Independent Assessment Report

Section 4.55(2) Application: 338 Botany Road, Alexandria - D/2019/87/C

File No.: D/2019/87/C

Figure 1: Proposed envelope plans - Ground (Note: existing approval provides for 4.5m western setback)

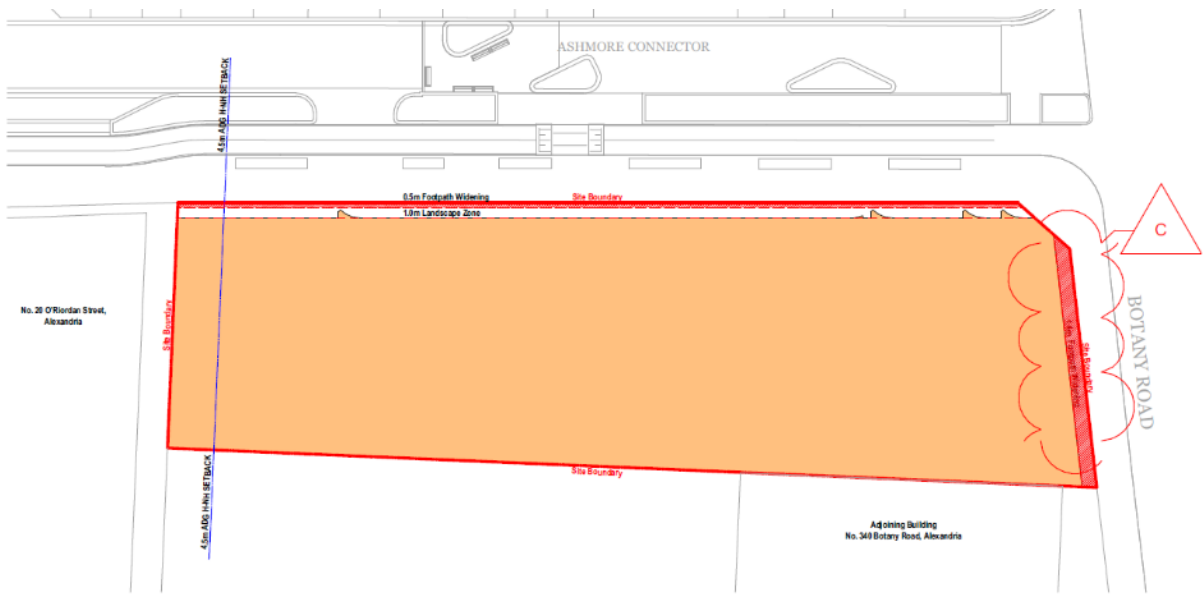
- Amend the building envelope on the western elevation at (a) ground level to facilitate the required disabled car parking spaces and loading dock, reducing the western setback at ground level from 4.5m to 0m and (b) partly at Levels 8 and 9 to reduce the setback from 9m to 7.967m,

Figure 4: Proposed envelope plans - Levels 8 - 9 (Note: existing approval provides for full 9m western setback. Proposed blade projections above ground level over setbacks)

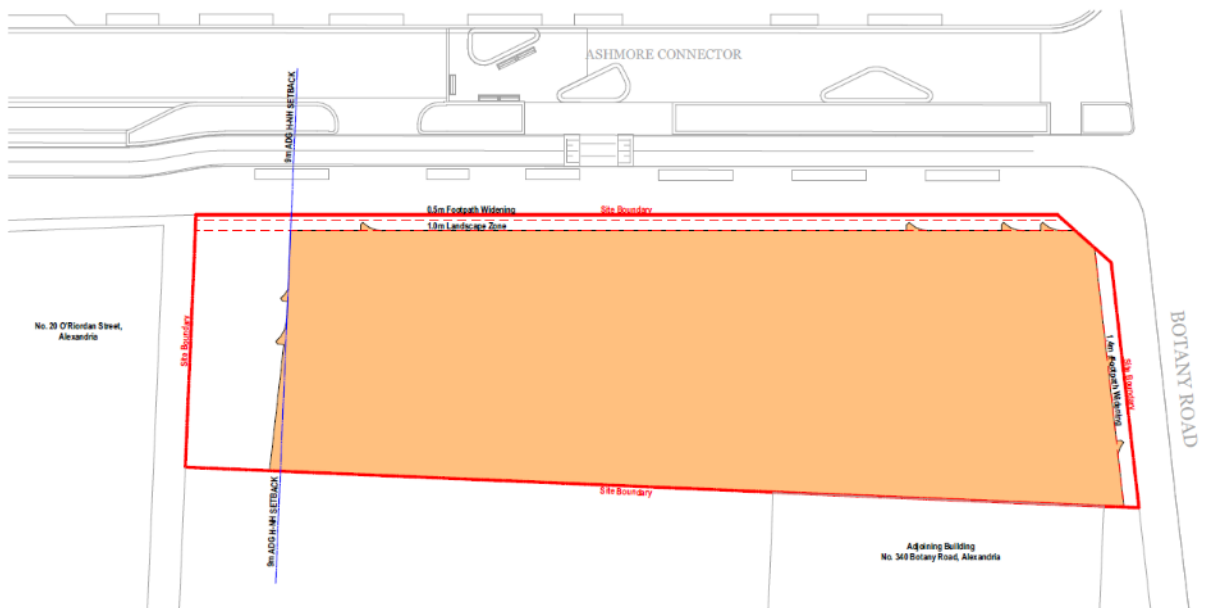
60. A change is also proposed at Levels 8 and 9 (and 10) which previously had a western boundary setback of 9m (in accordance with the ADG) but which is now proposed to be setback a minimum of 7.967m in the south western corner of the site increasing to 9m approximately 50% along the frontage as shown below. This is considered to be acceptable in the circumstances given that the development to the west as approved is commercial and 5 storeys in height. No privacy impacts will therefore result from the non-compliance.

Figure 23: Detailed Design DA Compliance with max height

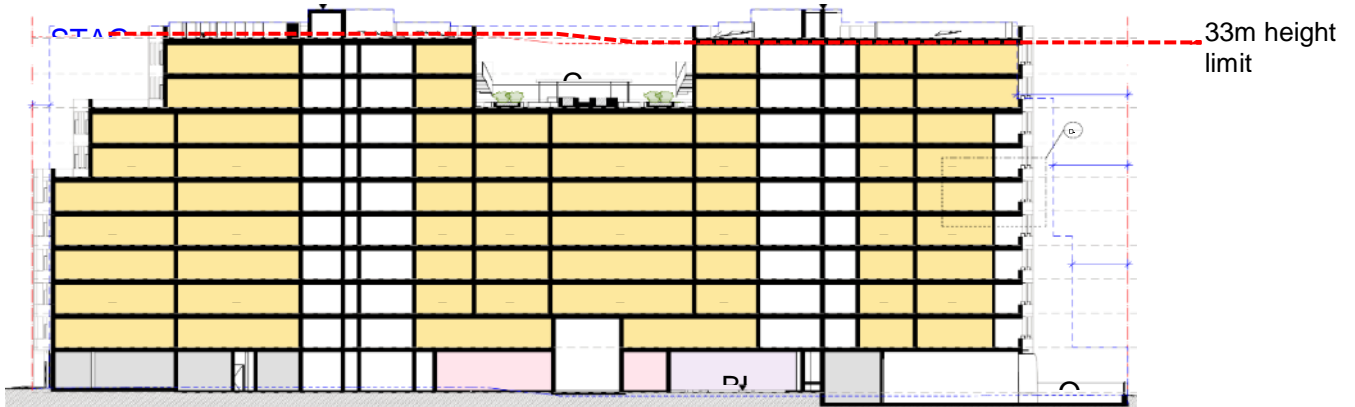
47. The application proposes to exceed the maximum 33m height of buildings development standard by 3.2m to a maximum of 36.2m (RL 50.8) (14.3% variation), as depicted in the building envelope diagrams above. As noted above, the applicant has indicated that the increase in height is required to:

48. The additional height is limited to the parapet, lift overrun, fire stair, hot water services and solar panels as shown on Figure 23 below which is extracted from the detailed design development application (D/2024/273). These elements are relatively minor and will generally not be visible or discernible from the street. As such, they do not contribute to the bulk and scale of the building.

The maximum height of the buildings must not exceed ~~33~~ **36.2** metres in accordance with the Sydney LEP 2012 **as provided for under D/2024/273**. No structures are to exceed the ~~33~~ **36.2** metres height limit.

Figure 31: Solar impact of detailed design DA (D/2024/273) on 499 and 501-509 Botany Road

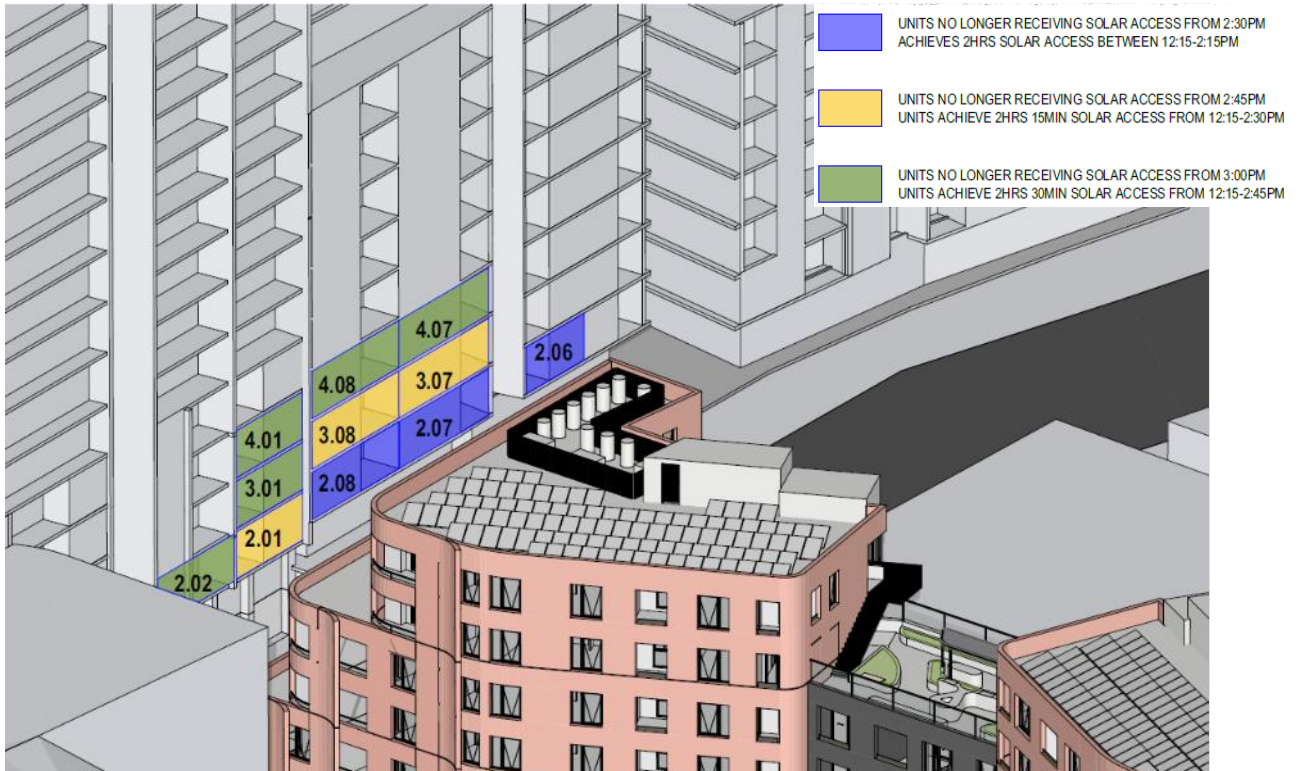
51. In respect of the existing approved developments at 499 and 501-509 Botany Road, the shadow impact is limited to after 2pm in midwinter as shown. Detailed solar access diagrams submitted with the detailed design development application (D/2024/273) show that the proposal will ensure that all units within the development at 499 and 501-509 Botany Road will continue to achieve a minimum of 2 hours of sunlight in midwinter. Shadows from the proposal do not extend over the subject site until after 2pm in midwinter. This is assisted by the stepping of the built form down toward the Botany Road frontage.

65. As outlined above the modification application also seeks to amend Condition (8)b which currently requires "no overshadowing of the approved residential apartments at 499 and 501 – 509 Botany Road, Alexandria". This condition is proposed to be deleted as the application has indicated that compliance with this requirement would result in the loss of approximately 14 affordable housing units. Additionally, condition (8)a requires that the subsequent detailed design development application "Minimise overshadowing on adjoining properties in accordance with ADG objective 3B-2". While the detailed design development application (D/2024/273) does result in some additional overshadowing of apartments within 499 and 501 – 509 Botany Road, Alexandria it minimises this overshadowing and demonstrate that notwithstanding the additional impact, a minimum of 2 hours of solar access will be retained to these units in midwinter between the hours of 9am and 3pm as required. Accordingly, it is considered that deletion of condition (8)b) is appropriate as it will provide for 14 additional affordable housing units whilst still minimising overshadowing impacts on neighbouring properties in accordance with condition (8)a).

Figure 26: Balconies including as GFA due to wall height - typical floor level

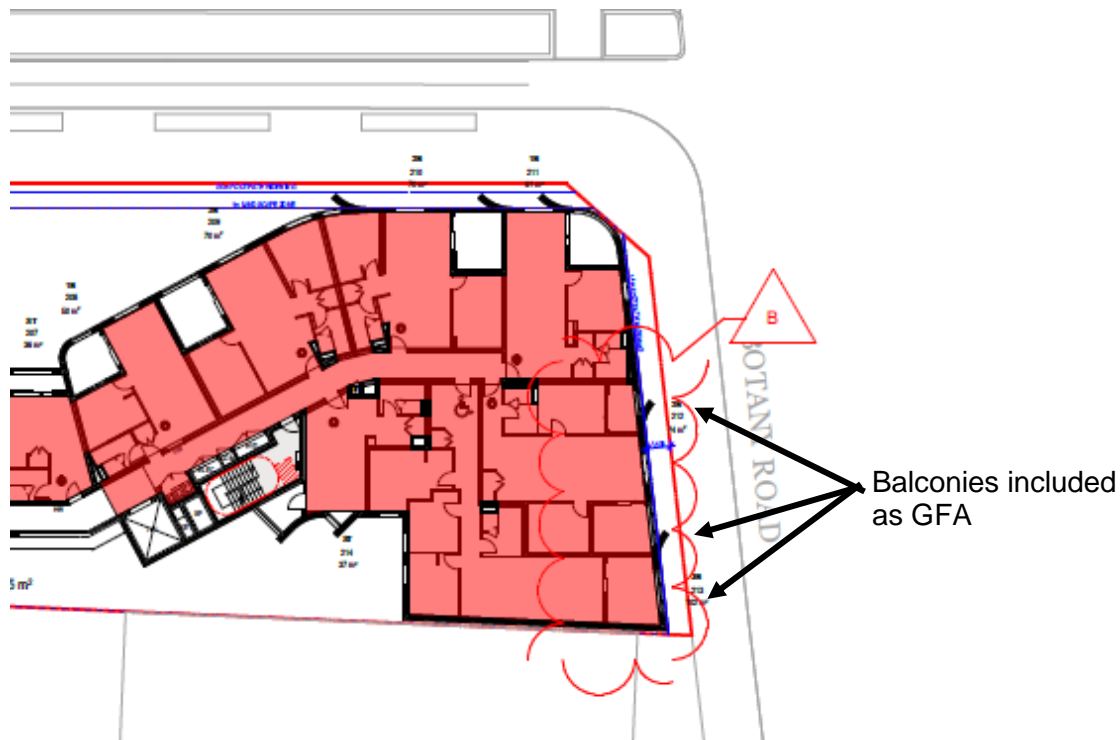
55. Therefore, as the walls to the east facing balconies have a height greater than 1.4m the area of the balconies must therefore be included as GFA. The modification application therefore seeks to modify condition 14 of the Concept Approval to provide for a maximum floor space ratio of 4.09:1 rather than the currently approved 4:1.

57. Consistent with the height discussion above, as a Section 4.55(2) modification application, Clause 4.6 of the Sydney LEP 2012 with regard to requesting a variation to the 'Floor Space Ratio' development standard does not apply. A Clause 4.6 variation request in respect of floor space ratio has been submitted as part of D/2024/273 and a detailed assessment carried out. The variation request has been assessed to be well-founded in this instance.
58. The proposed additional GFA will not result in any increase to the bulk of the building and is largely considered to be a technicality. Further it will not result in a change that would affect the proposal being substantially the same as originally approval. Accordingly, it is considered that the proposed increase to the FSR is acceptable.

The Floor Space Ratio for all detailed development applications on the site must not exceed 4.09:1 calculated in accordance with Clauses 4.4 and 6.14 of the Sydney Local Environmental Plan 2012.

Figure 26: Proposed envelope (southern elevation)

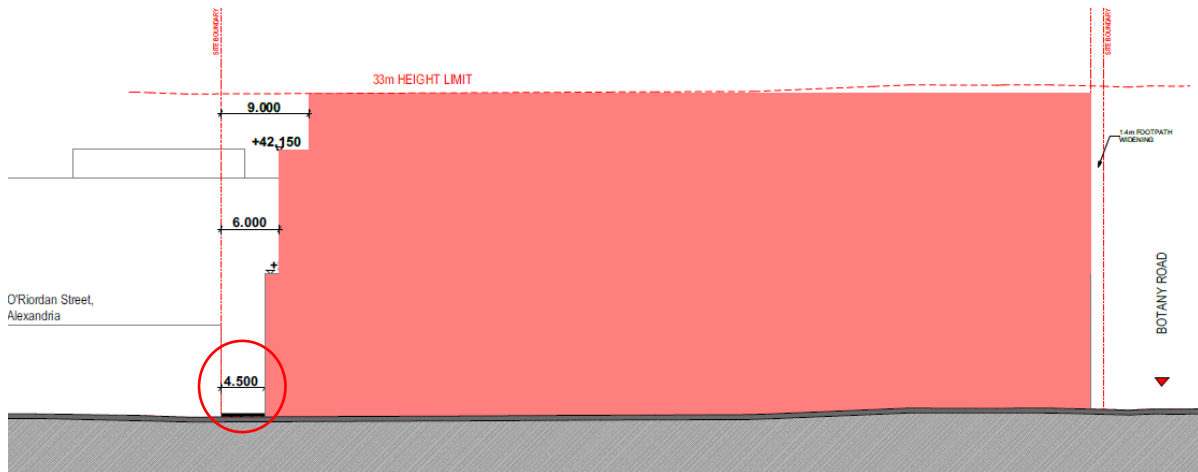
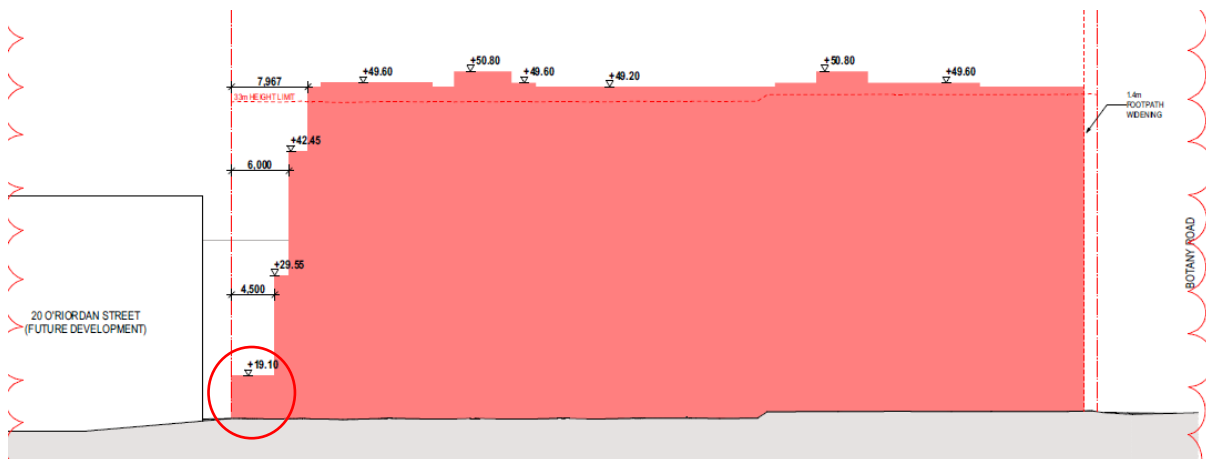
59. The proposed modification also seeks to amend the approved building envelope adjacent to the western boundary at the ground level to provide for a nil setback where previously a 4.5m setback was approved. The proposed nil setback is intended to be to an open but screened car park / loading area as outlined in the detailed design development application (D/2024/273). This change will not give rise to any privacy or other impacts and accordingly is considered appropriate in the circumstances.

Figure 29: Blade wall setback encroachments shown with red circle

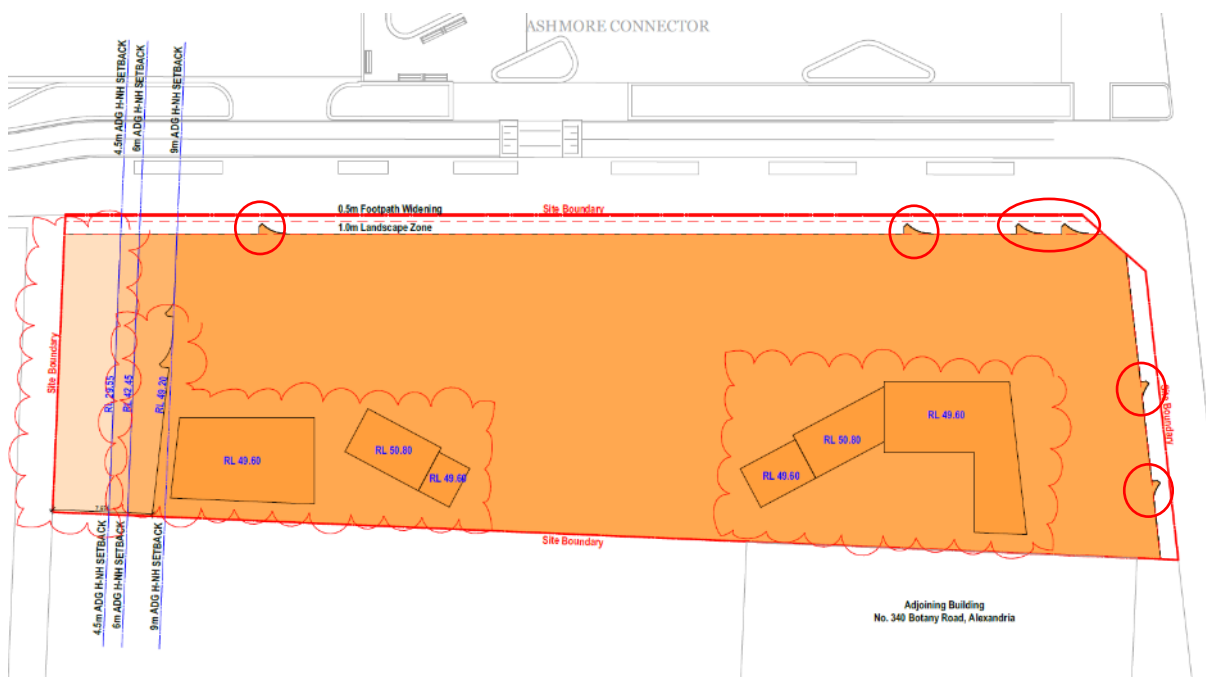
- 63. The proposed modification seeks to amend the approved building envelope adjacent to the northern and eastern boundaries to provide for architectural blade walls that project into the setbacks and footpath widening dedications above ground level (refer below). Originally these encroachments were proposed to extend to ground level however have been amended in response to Council's RFI comments. The proposed encroachments are approximately 800mm wide and will project above the landscape zone to the north and the footpath widening to the east. Generally, Council allows projections above footpaths of a maximum of 450mm however Council's specialist surveyor and public domain officer have advised that the proposed encroachment is acceptable in the circumstances.
